# Minor Development Final Plat Staff Report

**Date:** June 22, 2026  
**To:** Douglas County Planning Commission  
**From:** Carolyn Washee-Freeland, AICP, Senior Planner *CWF*  
Brett Thomas, AICP, Planning Manager *BT*  
Steven E. Koster, AICP, Deputy Director of Community Development *SK*  
**Subject:** Adragna – Minor Development Final Plat  
**Project File:** SB2024-030

**Planning Commission Hearing:** July 6, 2026 @ 6:00 p.m.  
**Board of County Commissioners Hearing:** July 14, 2026 @ 2:30 p.m.

**FIGURE 1**  
 Site Map

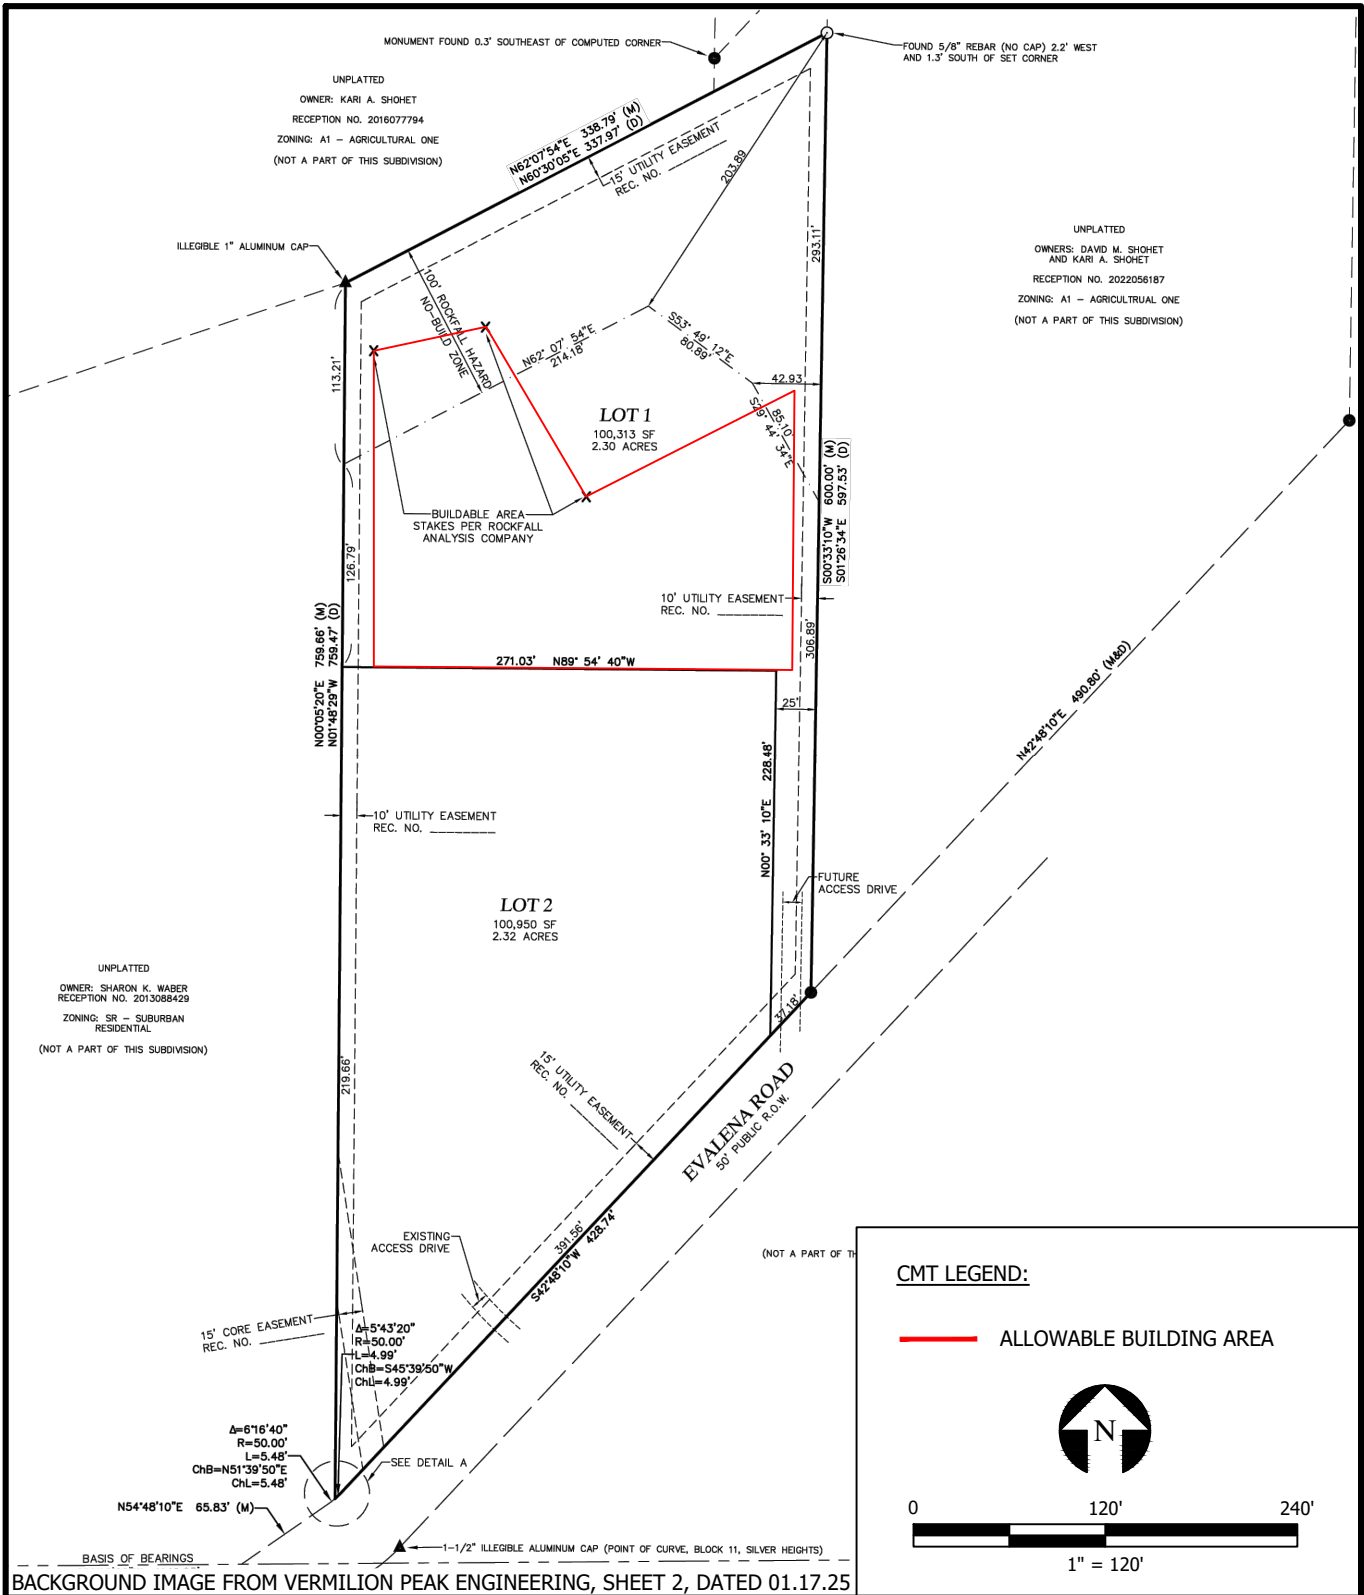
*We recommend that the proposed structures be constructed beyond a minimum setback distance of 100 feet from the northern property line, and 50 feet south and west of the centerline of the existing swale that is present in the northmost portion of the site, as shown in Figure 2C. The swale will provide a natural barrier or catchment area for rockfall.*

*Avoidance is the preferred mitigation method for rockfall and other geologic hazards.*

*Staff Comment: CGS requested a Rockfall Analysis Report for the subject property. A No-Build Zone and a Building Envelope were established on the plat to avoid potential rockfall hazards present on the northern portion of the site. No structures are permitted within the no-build zone, and future lot owners will need to obtain site specific geotechnical recommendations prior to building permit issuance, before construction on Lot 1.*
